UNITED STATES  
DEPARTMENT OF THE INTERIOR  
BUREAU OF LAND MANAGEMENT

FORM APPROVED  
OMB NO. 1004-0135  
Expires: July 31, 2010**SUNDRY NOTICES AND REPORTS ON WELLS OIL CONSERVATION**  
**Do not use this form for proposals to drill or to re-enter an abandoned well. Use form 3160-3 (APD) for such proposals.**ARTESIA DISTRICT  
DEC 02 2016**SUBMIT IN TRIPLICATE - Other instructions on reverse side.**

CHEVRON USA INC IS REQUESTING TO RECOMPLETE THE ABOVE SUBJECT WELL IN THE WOLFCAMP. PLEASE FIND ATTACHED PROPOSED AND CURRENT WELLBORE DIAGRAMS. THE PROCEDURE TO RECOMPLETE WILL BE AS FOLLOWS:

**Henshaw A Federal 1  
30-015-32891  
Chevron USA Incorporated  
November 11, 2016  
Conditions of Approval**

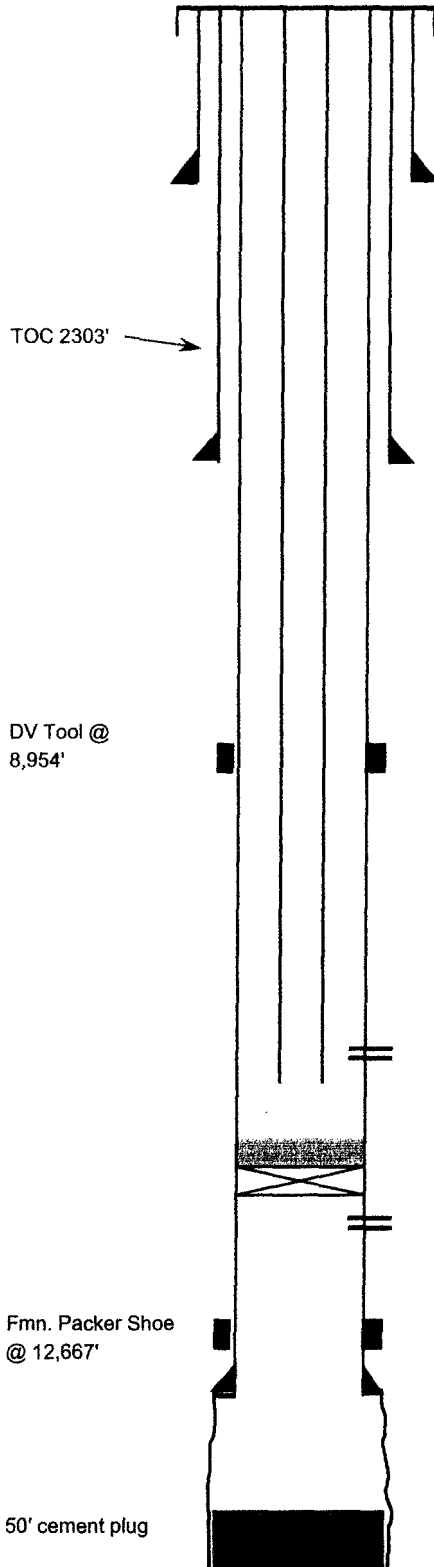
1. MIRU PU. KILL WELL
2. PULL RODS AND PUMP
3. ND WELLHEAD. NU BOP.
4. TOH WITH 2 3/8" L-80 TUBING. *perfs there*
5. RIH W/CIBP AND SET @ 12,574'. TAG CIBP W/SETTING TOOL TO ENSURE A GOOD SET. RIH W/DUMP BAILER *see CIBP* AND DUMP 35' OF CEMENT ON TOP OF CIBP.
6. PU PERFORATING SERVICES, RU LUBRICATOR. PERFORATE WOLFCAMP INTERVAL FROM 8,774' - 8,787.
7. TIH WITH 5 1/2" TREATING PACKER ON 2 7/8" WORKSTRING AND SET PACKER AT 8,700'.
8. ACIDIZE PERFS WITH 2,000 GALLONS OF 15% HCL. DIVERT USING BALL SEALERS.

**Current Wellbore**

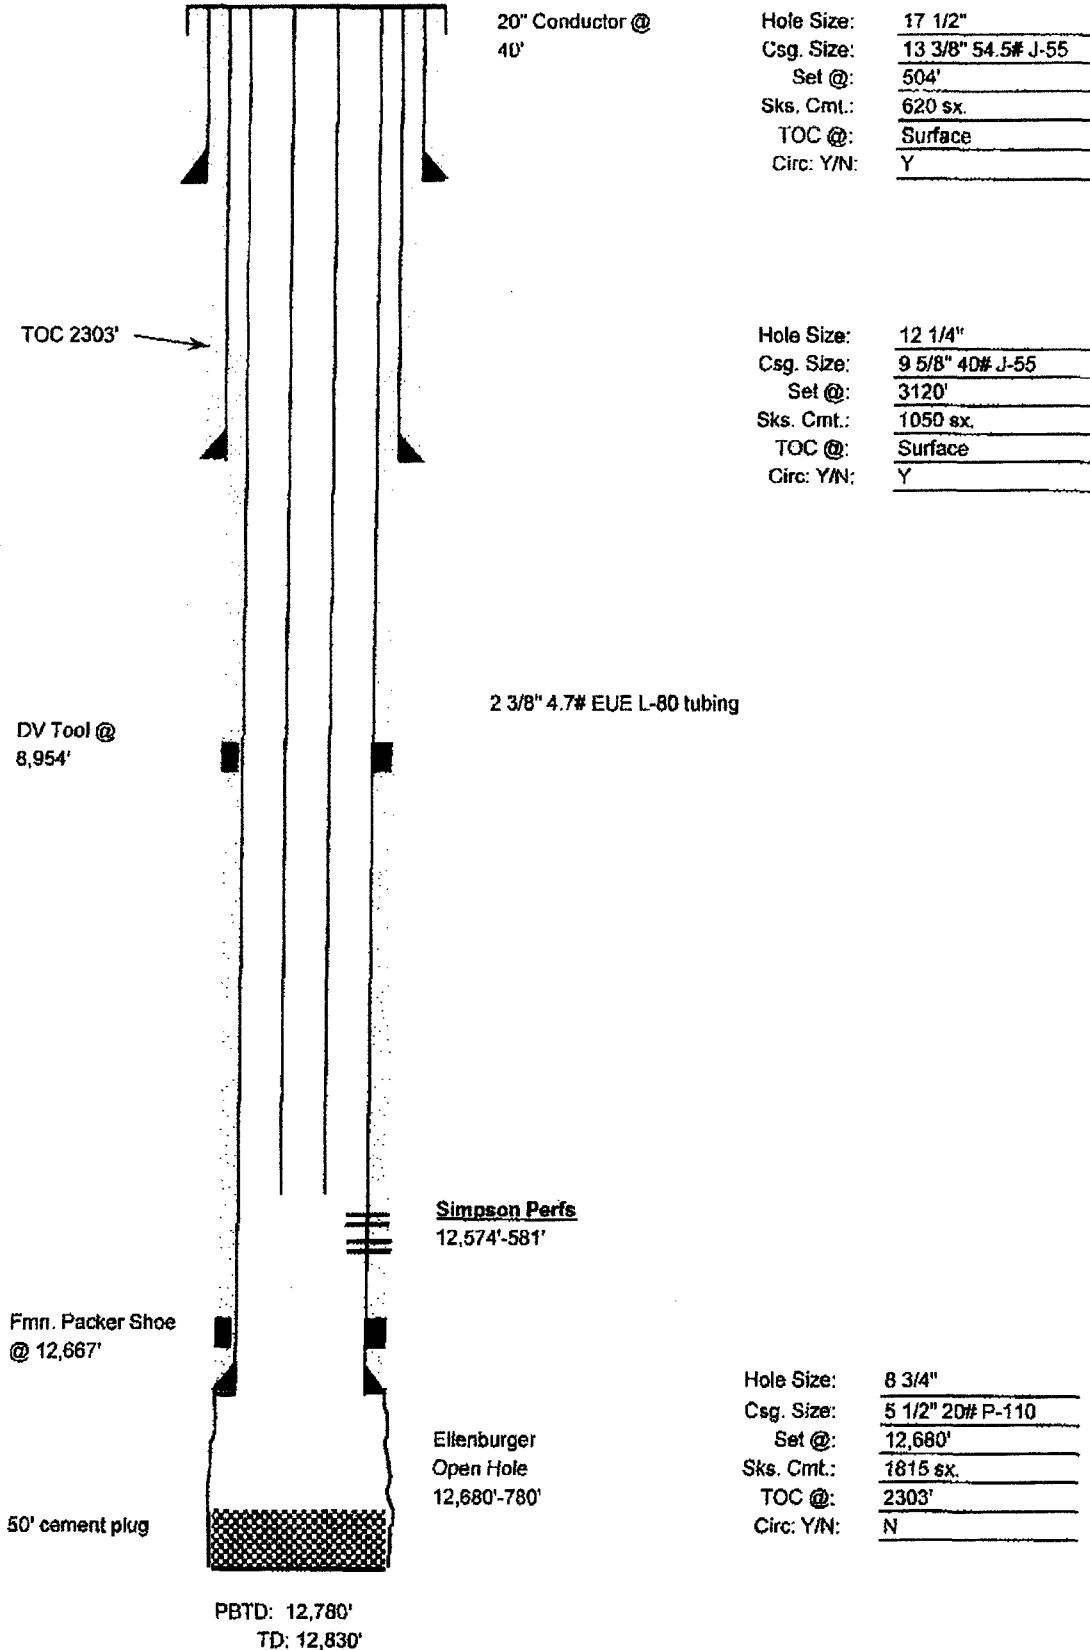
- 1. Operator shall place solid Class H cement plug from 12,717'-12,617' to seal the casing shoe. WOC and TAG.**
- 2. Operator shall set CIBP at 12,524' (50'-100' above current perfs) with a minimum of 25 sx Class H cement on top. WOC and TAG required.**

- 3. Operator shall place solid Class H cement plug from 10,225'-10,428' (spacer plug). This plug can be placed now or at the time the Wolfcamp is abandoned.**
